Re: 2400 E Atlantic Ave Pompano Beach, FL

Florida Power and Light Response Letter

PZ25-12000001

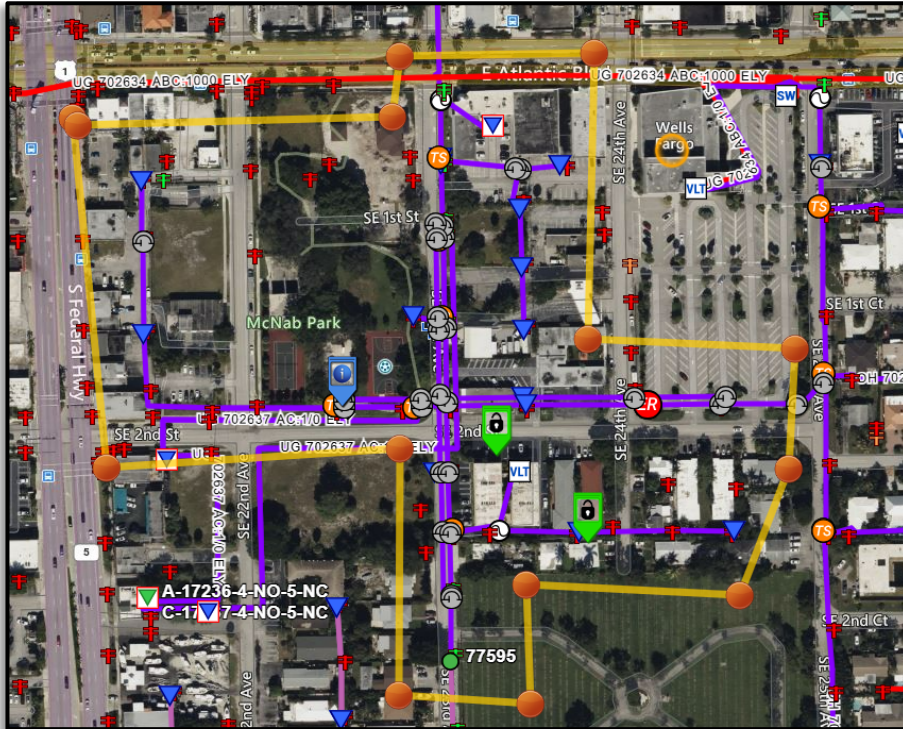
Additionally, while the 1000 foot or 2 block requirement is what we are required to offer for consideration, I would like to point out that the existing facilities on the south of the property heading east along SE 2<sup>nd</sup> St would likely see a net negative impact on the strength of the grid if converted in the event it is limited to this constraint. I highly doubt that our area management team would approve us from an engineering side to perform the conversion unless it encompasses everything on our feeder 702637 that is south of E Atlantic Blvd between S Federal Hwy and SE 25<sup>th</sup> Ave as this area is fairly congested with a lot of Automatic Lateral Switches [ALS]. To be clear, ALS are a technology that further works to isolate a fault on our lines by first trying to troubleshoot the fault before opening the fuse. An underground equivalent is currently in the testing phase with our product engineering department, but as it stands now, they are not available for implementation in the field. I cannot say with full confidence that, even with the area outlined in the attached image, the area planning team will be agreeable for this reason.
